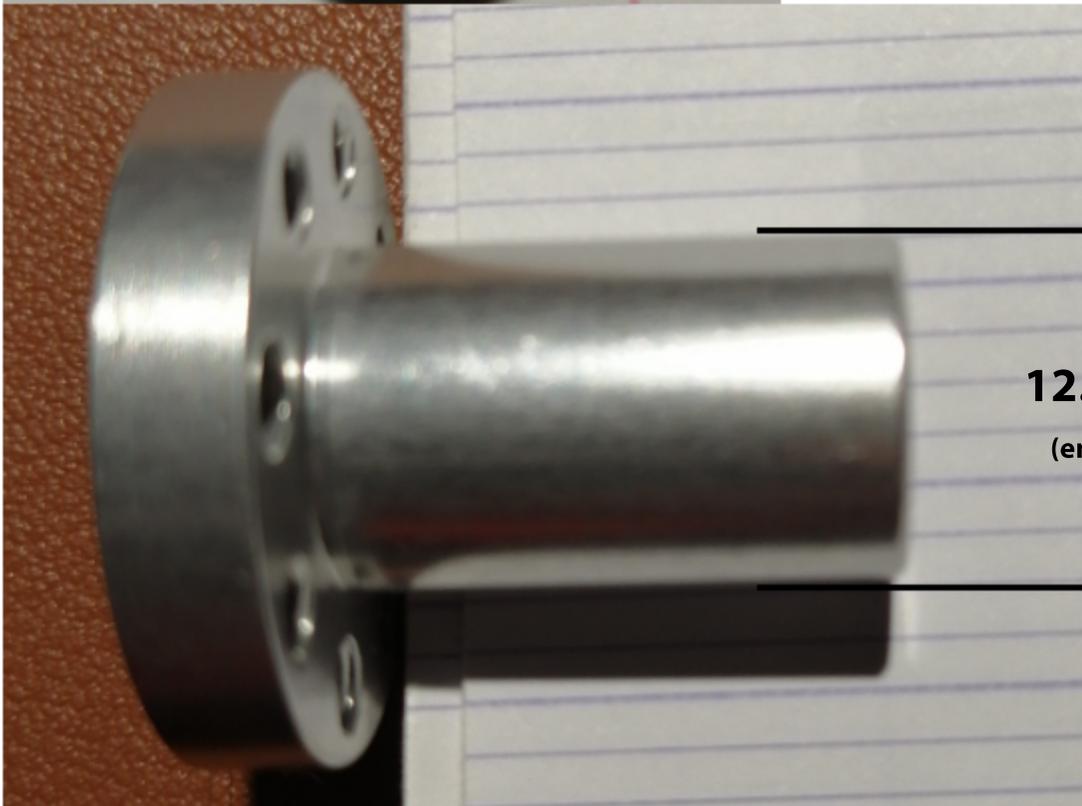
12.6 mm -> 11.6 mm
(enlever 0.5 sur le diamètre)

12.6 mm -> 11.6 mm
(enlever 0.5 sur le diamètre)
